**CITY OF BELMONT  
PLEASANTS COUNTY, WEST VIRGINIA  
CONTRACT #3 – WATER STORAGE TANK  
ADDENDUM #1  
JULY 26, 2024  
THRASHER PROJECT #T10-11028**

A Pre-Bid Conference was held on Tuesday, July 23, 2024 on the above-referenced project, a copy of the sign in sheet is included in this Addendum #1. The following are clarifications and responses to questions posed by contractors for the above-referenced project.

CITY OF BELMONT  
 WATER SYSTEM IMPROVEMENT PROJECT  
 WATER STORAGE TANK  
 BOLTED STEEL TANK  
 PLAN AND ELEVATION

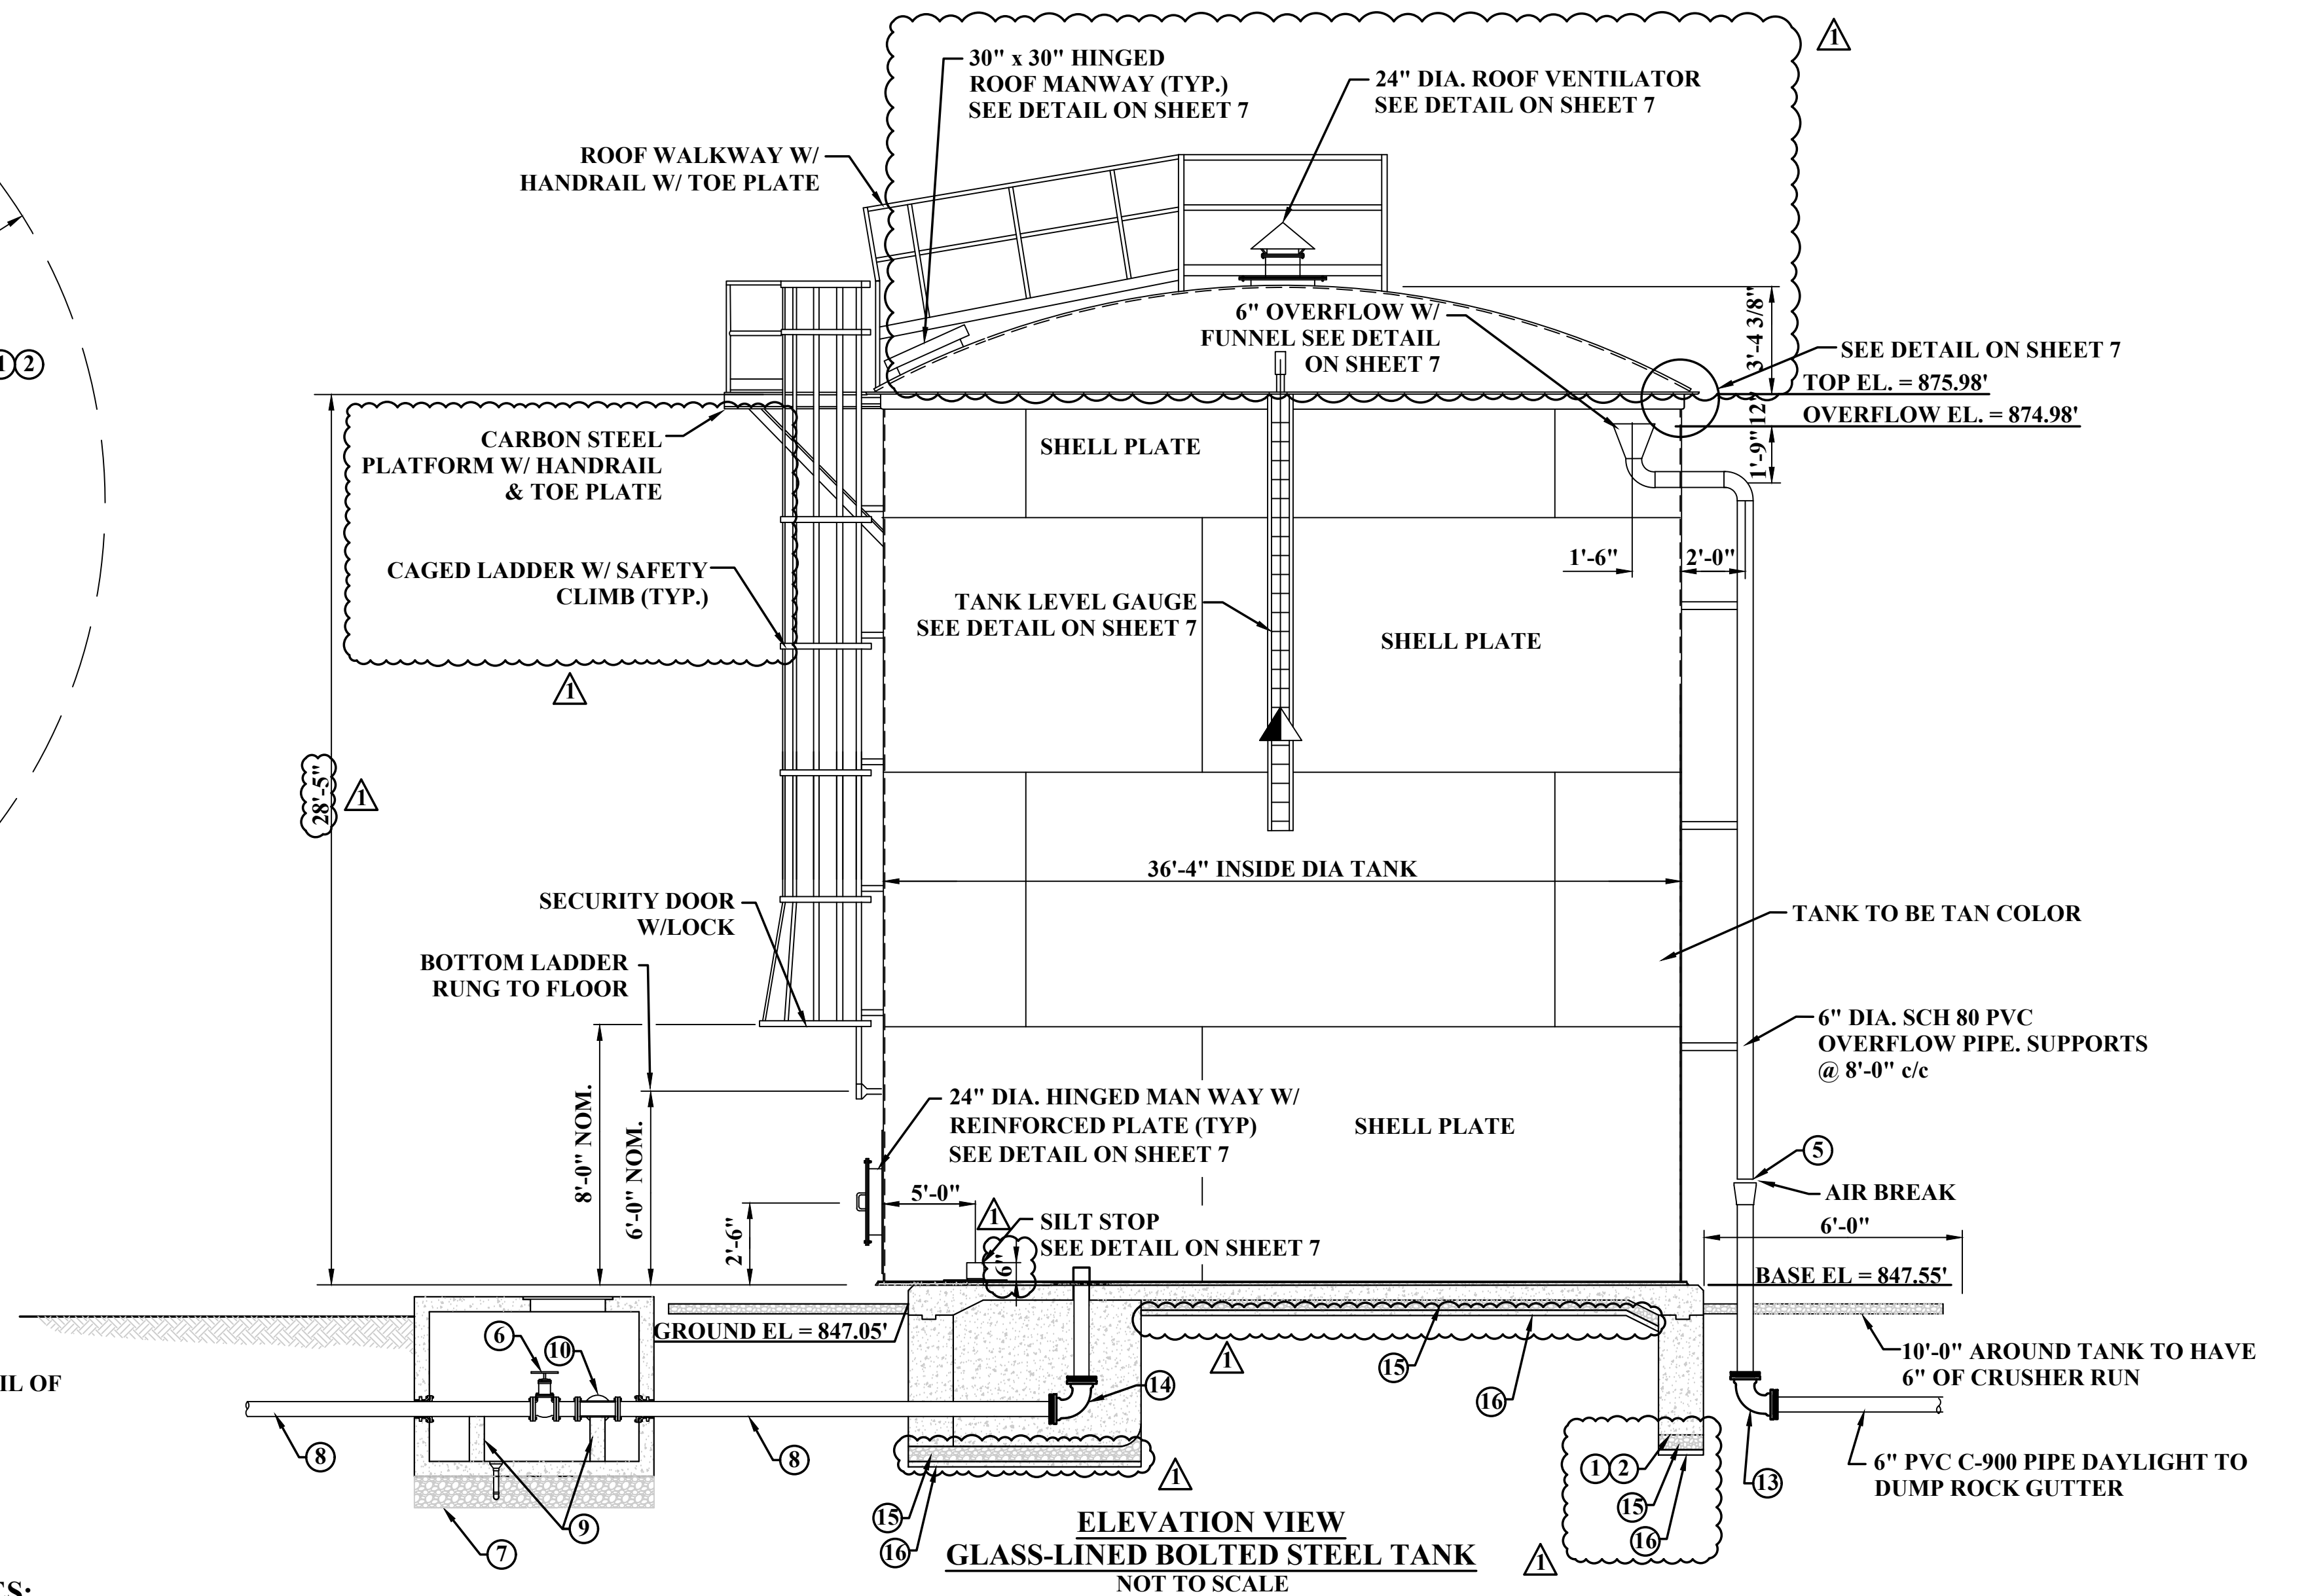
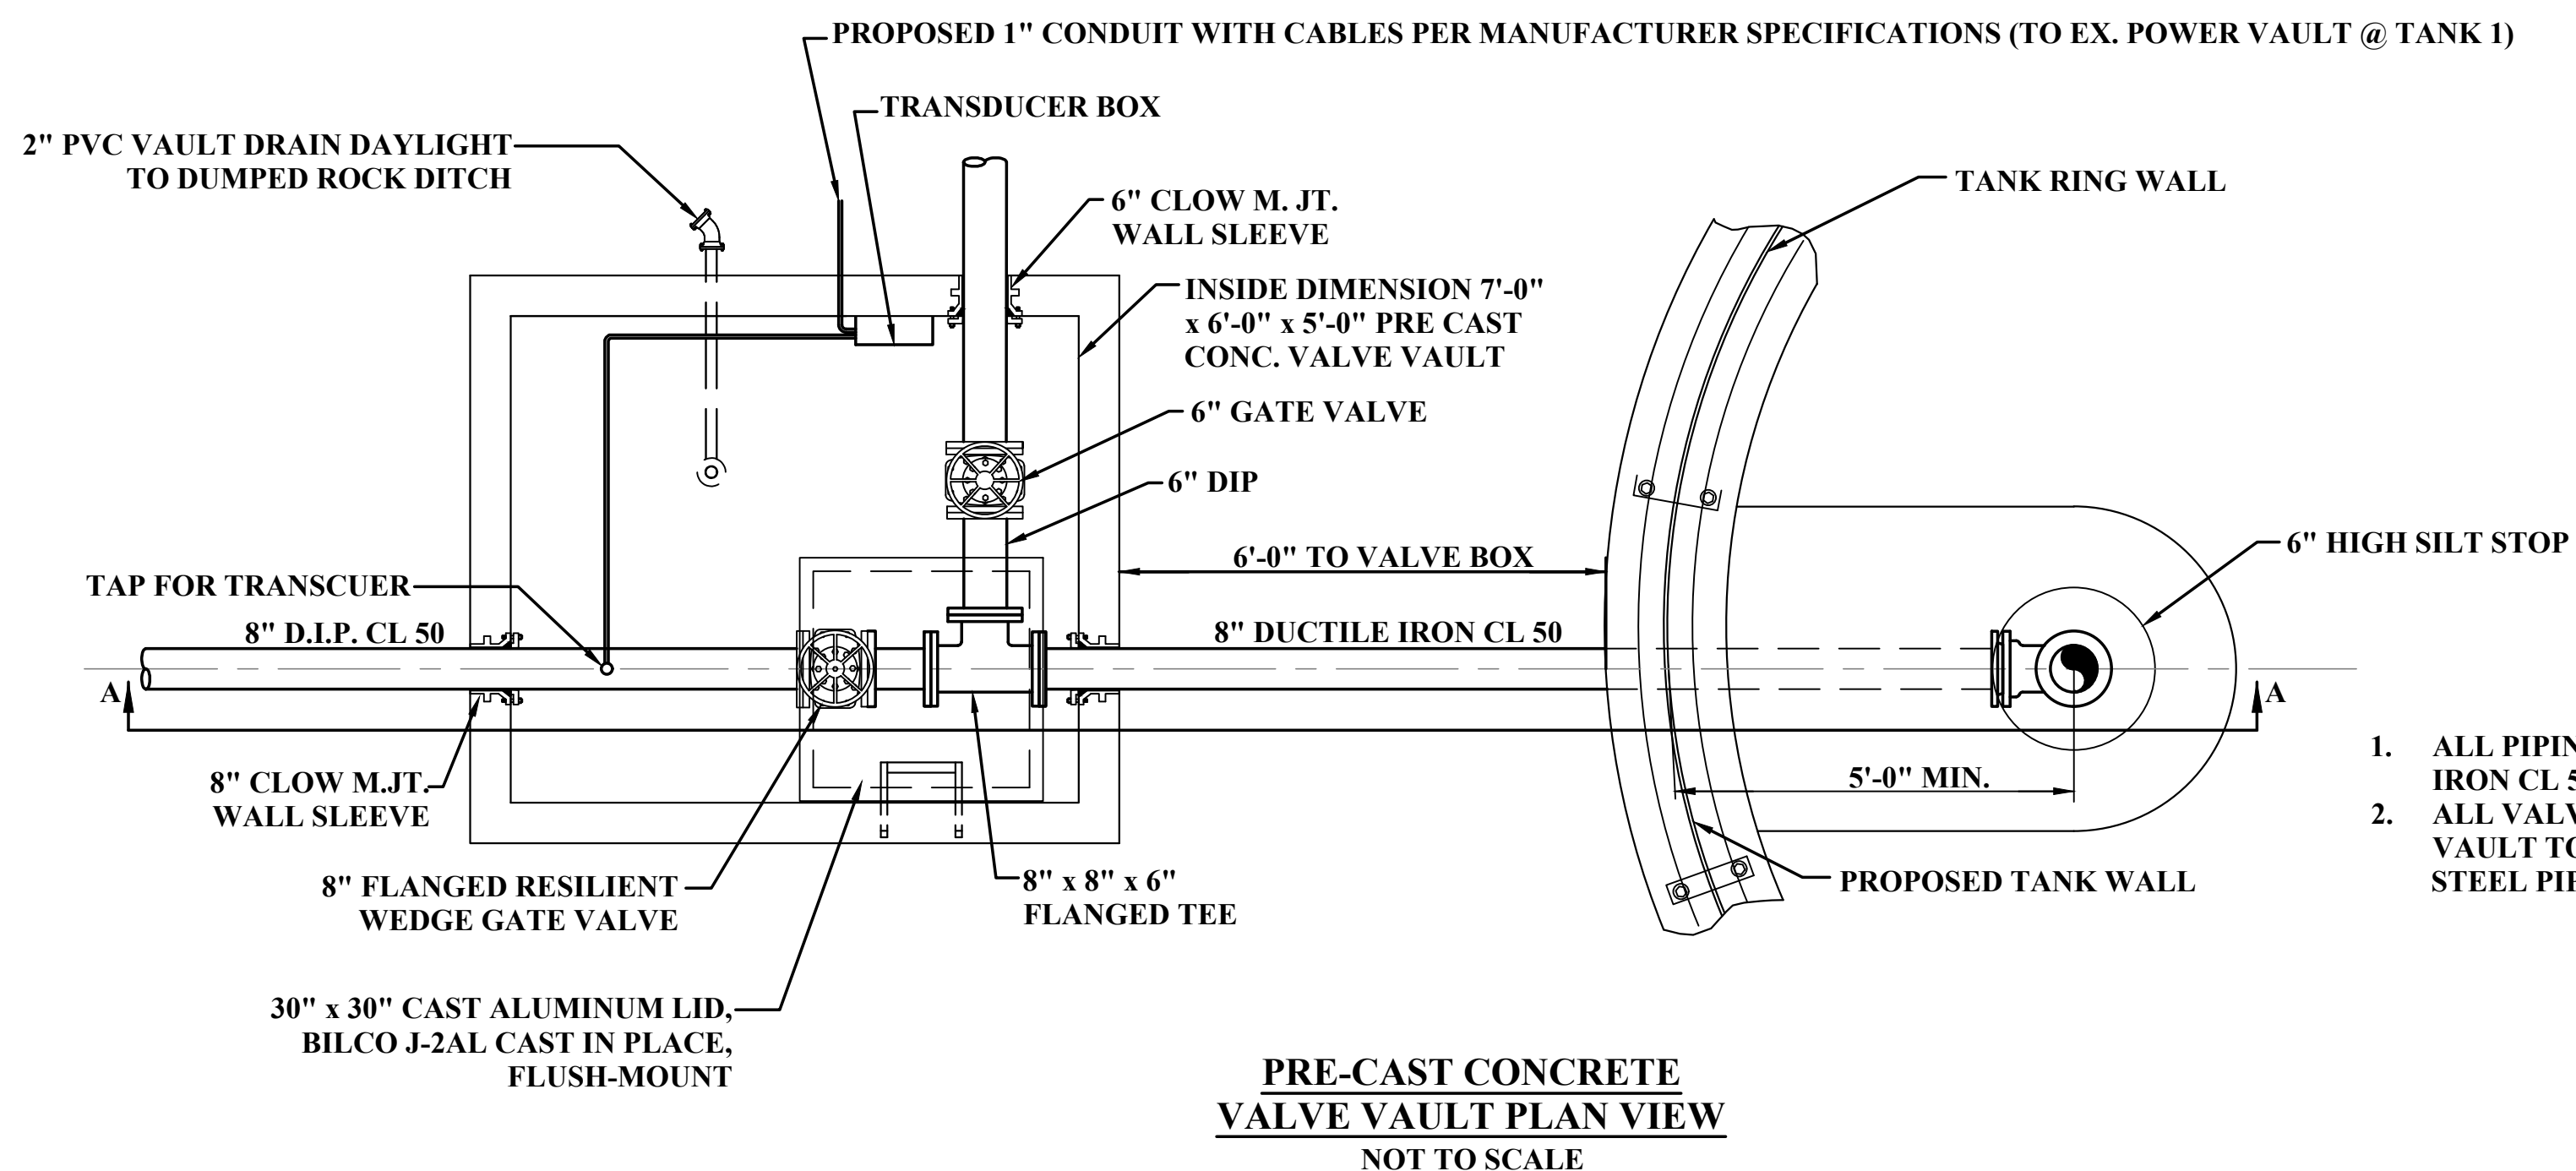
The tank diameter shown on Sheet 5 shows a dimension of 33'-6". This should be 36.36'. It looks like on Sheet 6 it shows 36'.

Drawing 5 shows a 3/16" Thick Self-Supporting Umbrella Roof. Is Mid Atlantic's Standard Geodesic Aluminum Dome Roof acceptable for the Glass Coated Steel Bolted Tank Option?

On Sheet 5, it shows the Silt Stop to be 6". On Sheet 6 of the Plan View, it shows 6". On the Elevation View of Sheet 6, it shows 8". Which do you want?

The plan sheet has been revised and is included with this Addendum #1.

Yes.

Silt stop shall be 6".

CITY OF BELMONT  
 WATER SYSTEM IMPROVEMENT PROJECT  
 WATER STORAGE TANK  
 BOLTED STEEL TANK  
 VALVE VAULT

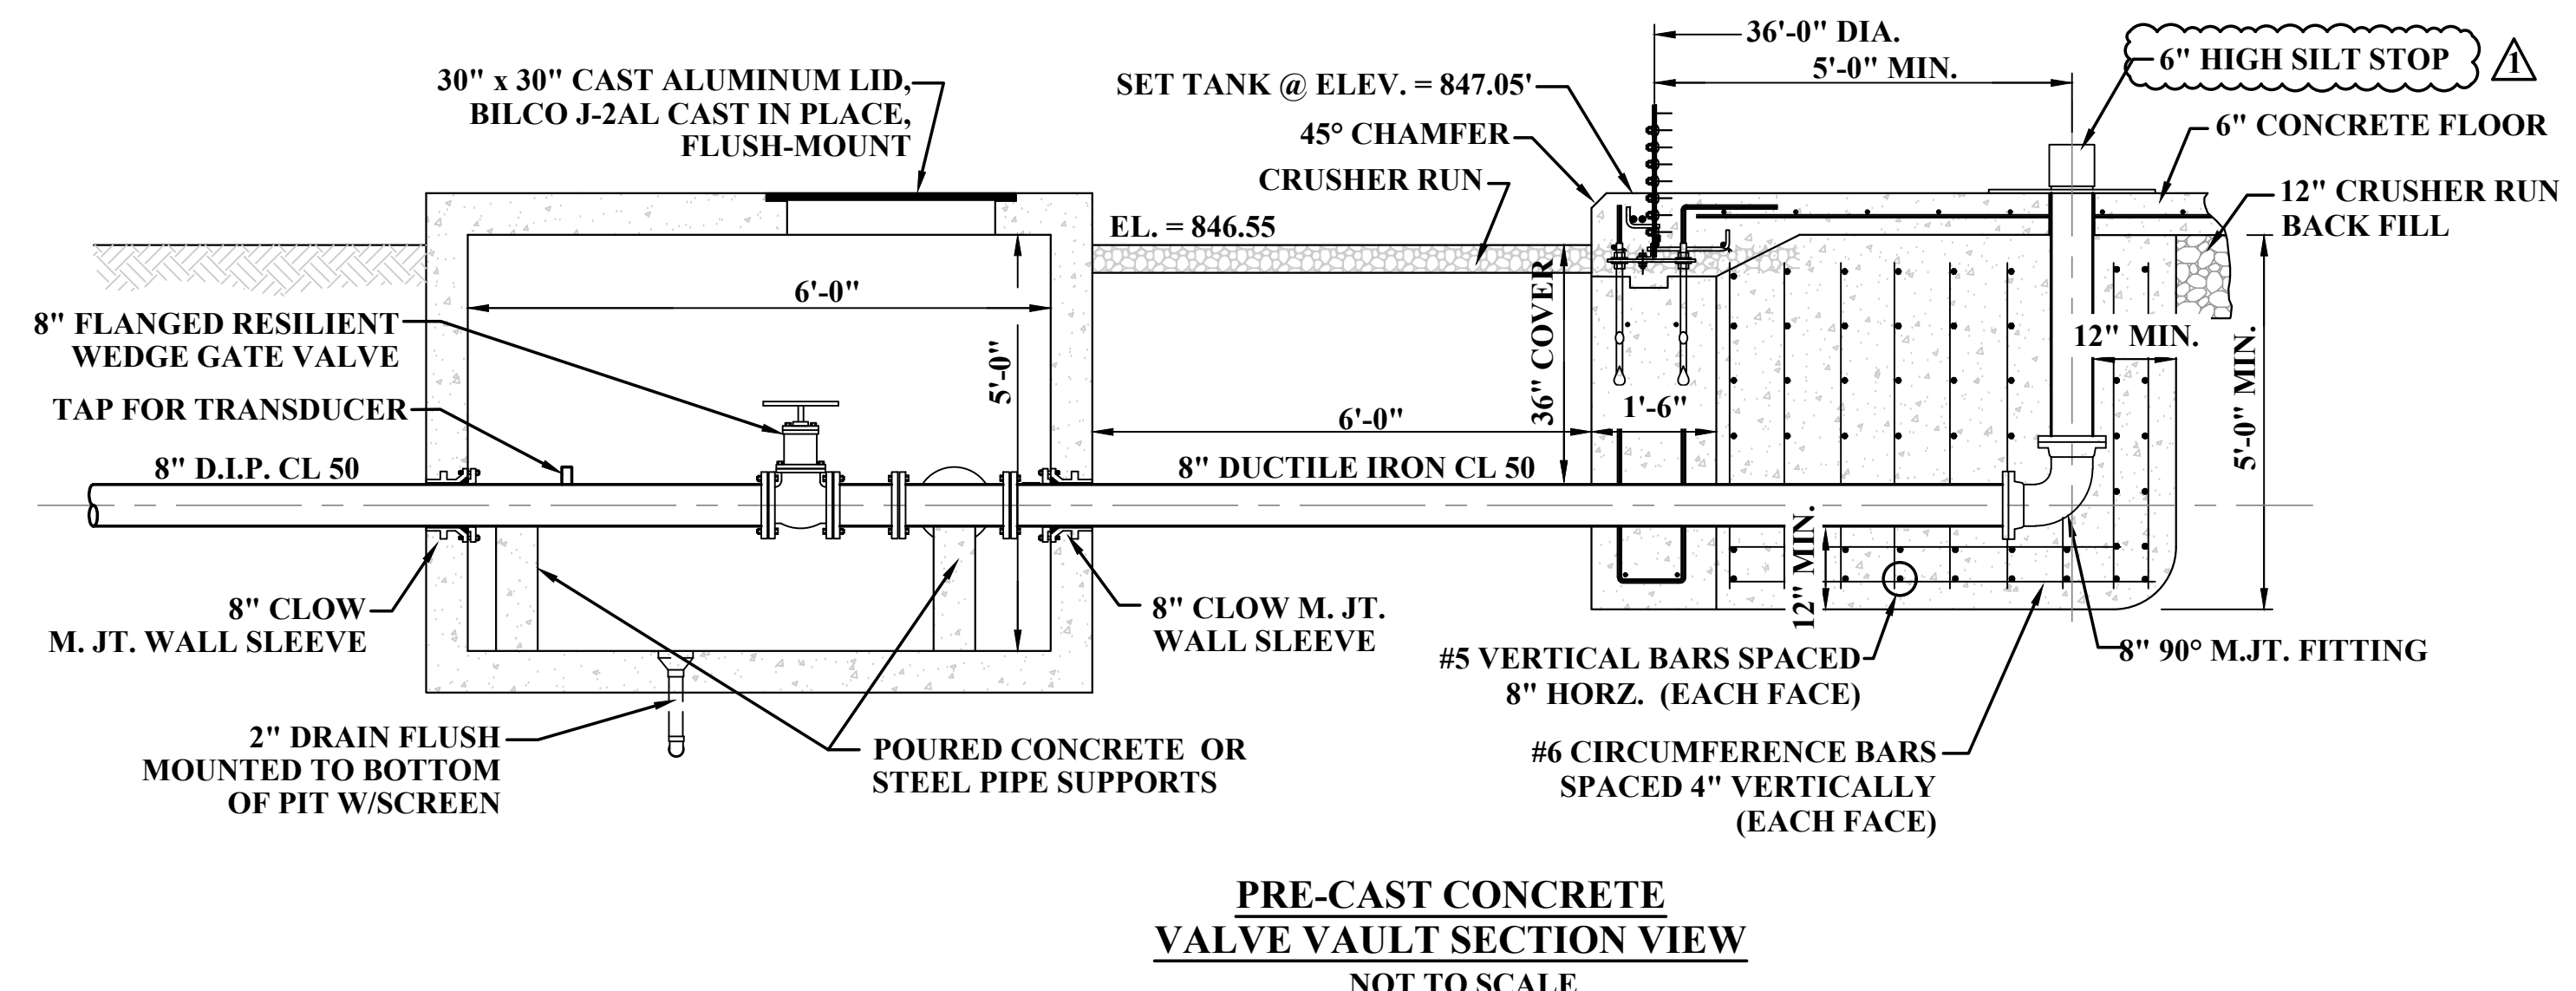
NO.	BY	DATE	DESCRIPTION
1	SWB	07/24/24	HIGH SILT STOP
